UNITED STATES  
NUCLEAR REGULATORY COMMISSION  
WASHINGTON, D.C. 20555-0001

SUBJECT: SHEARON HARRIS NUCLEAR POWER PLANT, UNIT 1 – SAFETY  
EVALUATION REGARDING IMPLEMENTATION OF MITIGATING  
STRATEGIES AND RELIABLE SPENT FUEL POOL INSTRUMENTATION  
RELATED TO ORDERS EA-12-049 AND EA-12-051 (CAC NOS. MF0874 AND  
MF0792)

SHEARON HARRIS NUCLEAR POWER PLANT, UNIT 1

Figure 14A

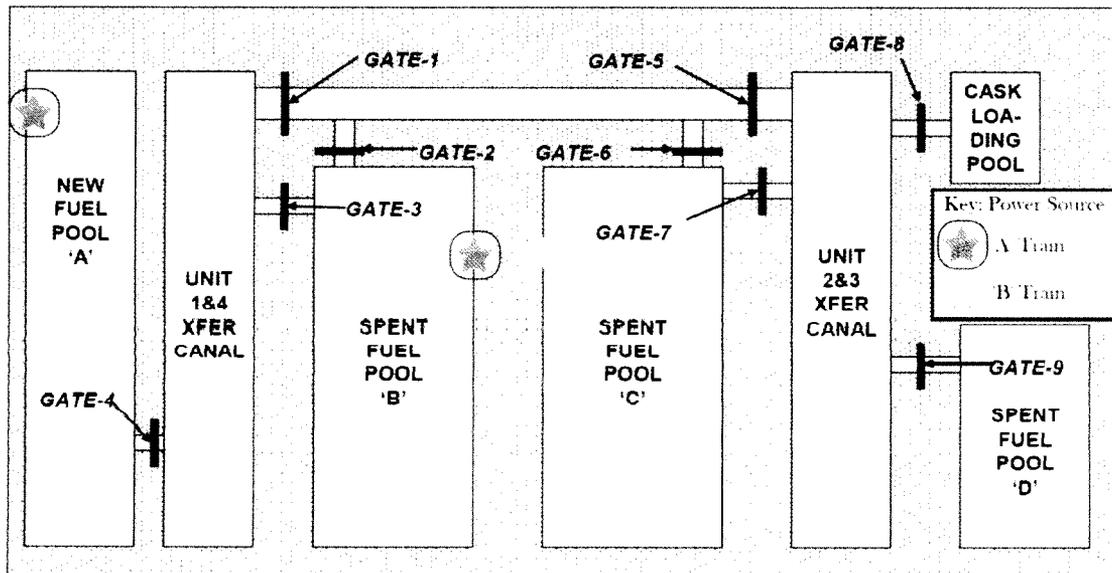
However, the NRC staff questioned how the instruments would respond under various combinations of gate closures. In response to the NRC staff's concern, in its compliance letter [Reference 18], the licensee stated that Figure 14A shows the approximate location of each channel and the associated power supply for the SFPLI that monitors the SFPs.

Based upon the pool interconnections and gate locations shown in Figure 14A, there are numerous gate installation combinations that may impact availability of the SFP level instrument channels. Examples of various gate combinations and the impact upon instrument availability are provided in the table below. Examples 4 and 5 also incorporate the combined effect of gate isolation and requirements for independent power sources. The impact of gate configuration, power isolation, and functionality is described below the table to support the examples identified.
